PROJECT: Chesterwood Village Phase 2: Light Care Assisted Living and Main Street
8073 Tylersville Rd.
West Chester, Ohio 45069

Correction Letter Response #1: Engineer Plan Review 3-16-07, Question Responses.
Application # BLD-CT07-00729

Application: BLD-CT07-00729

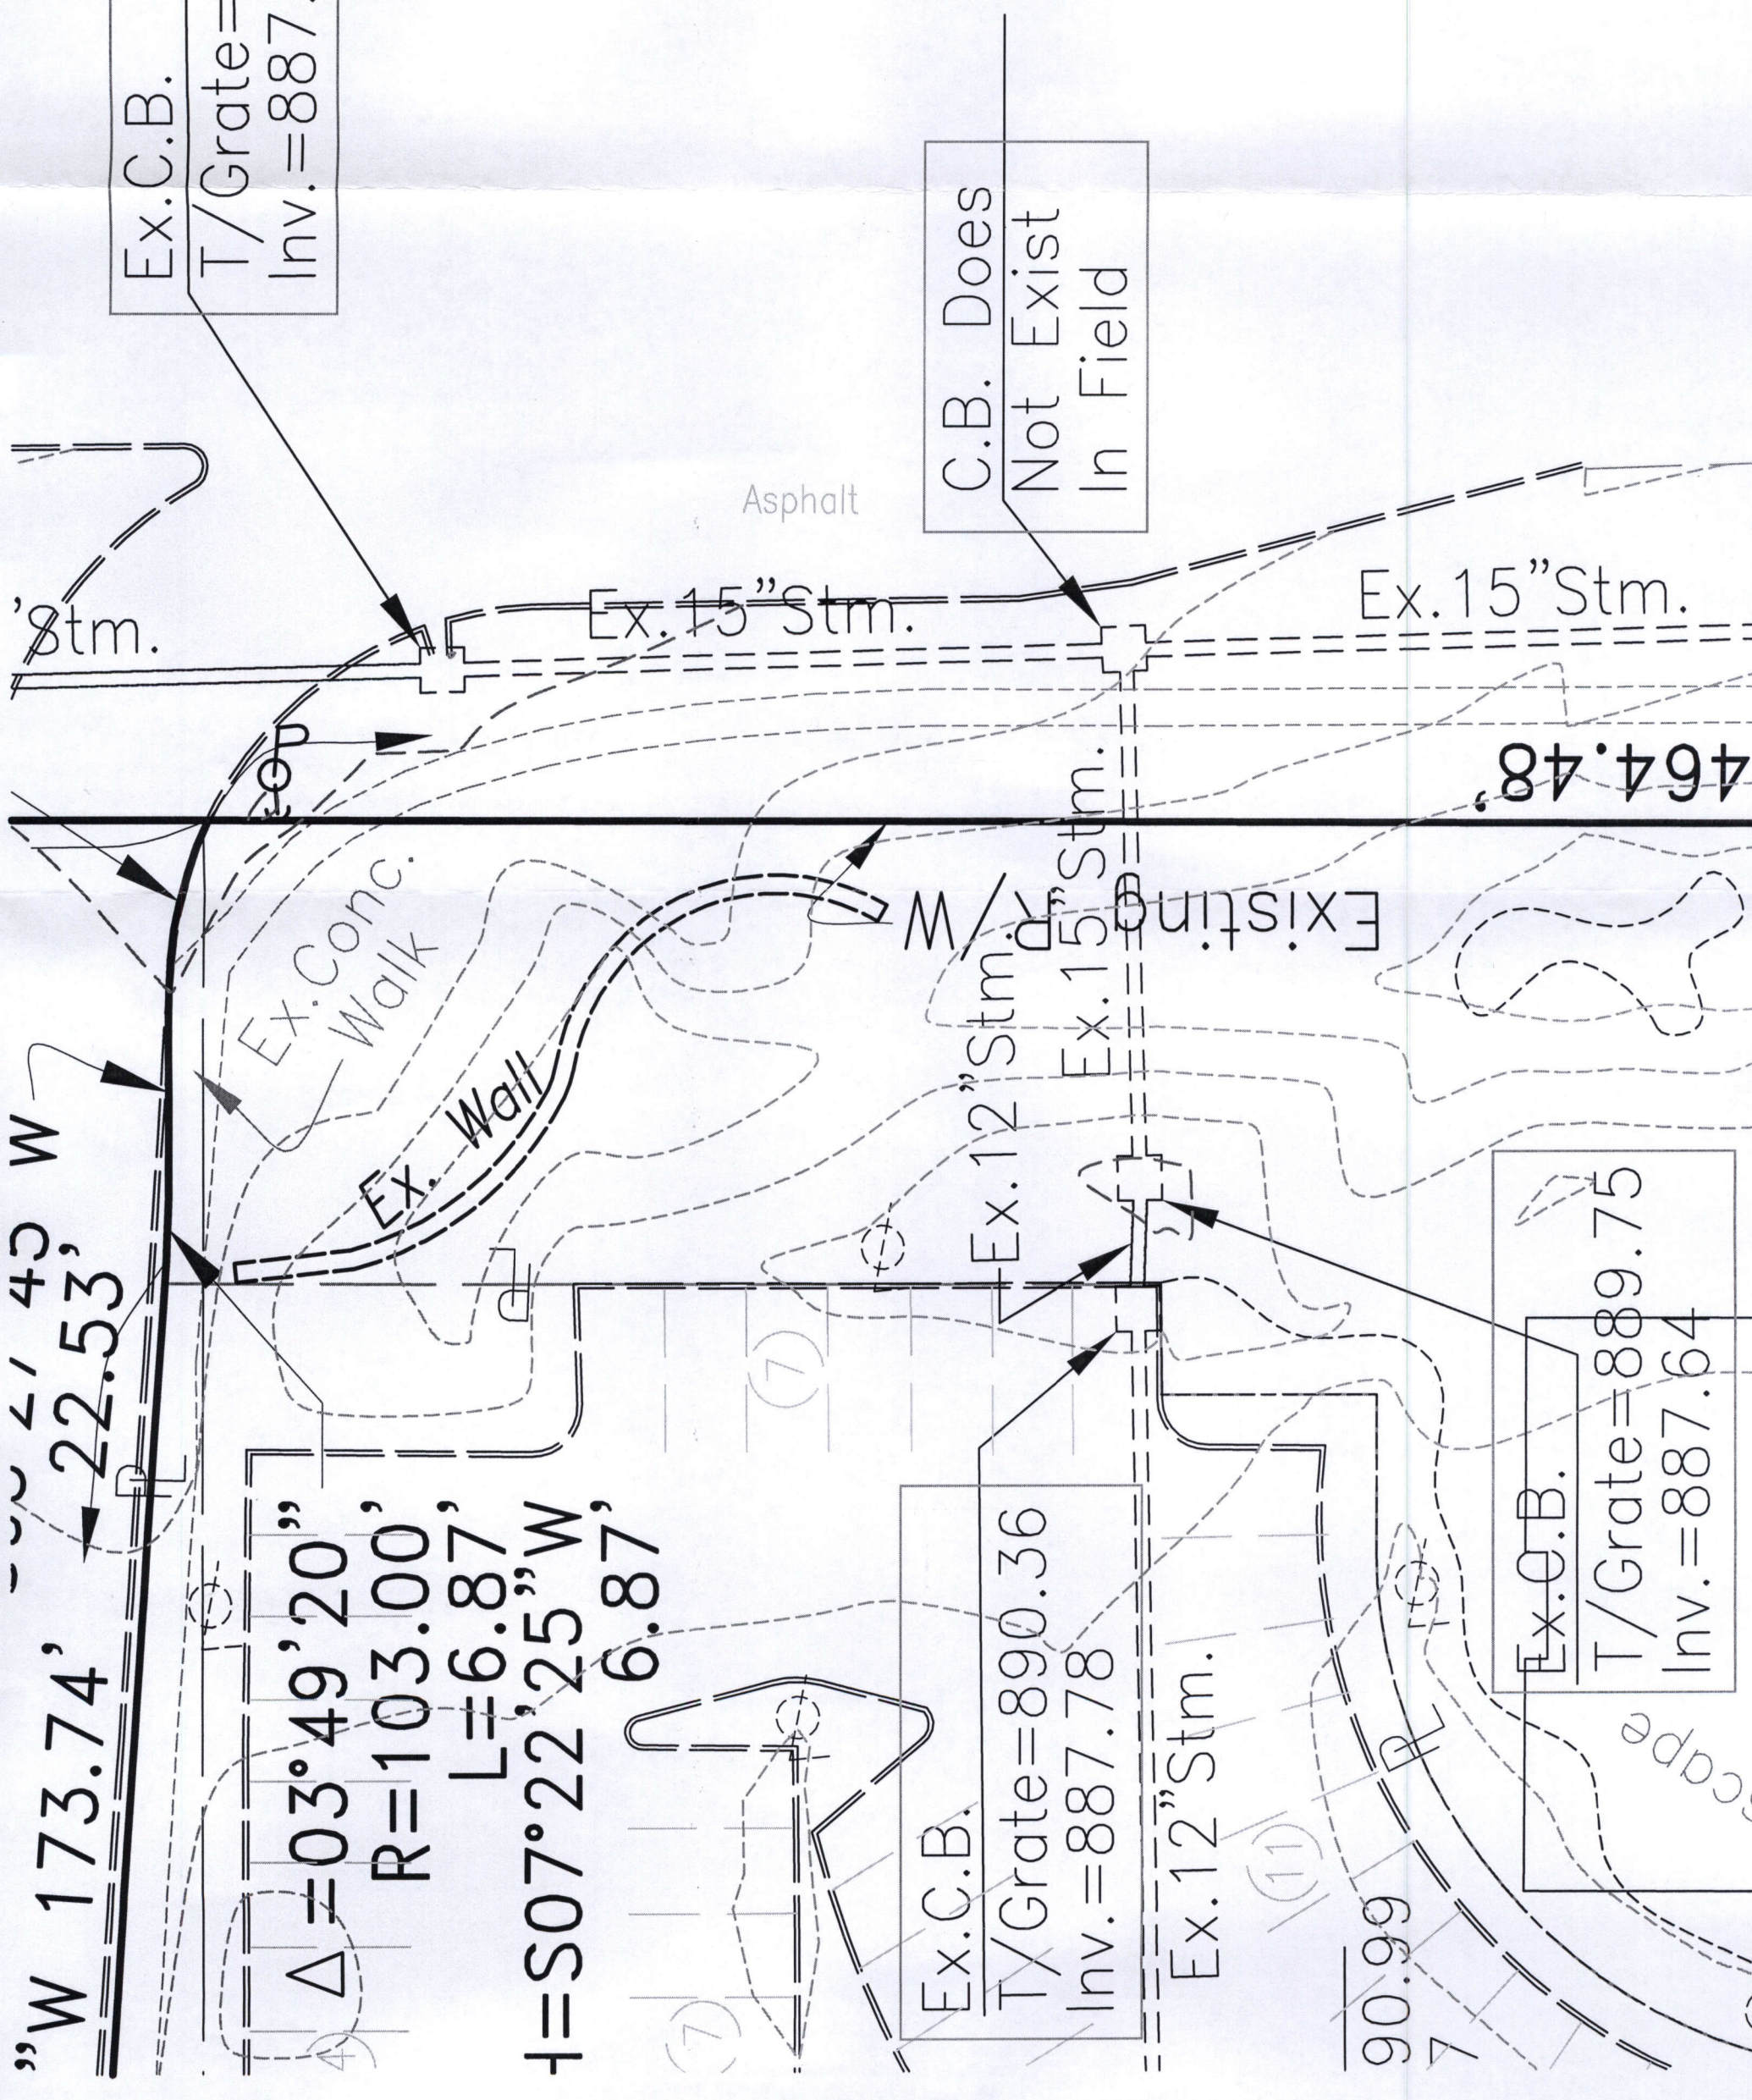
Please find enclosed a pdf file showing the revised as-builts. The portions in the blue boxes are the ones that have changed.

Ex.C.B.
T/Grate=889.39
Inv.=887.04

Ex.C.B.
T/Grate=890.36
Inv.=887.78

Ex.C.B.
T/Grate=889.75
Inv.=887.64

C.B. Does
Not Exist
In Field
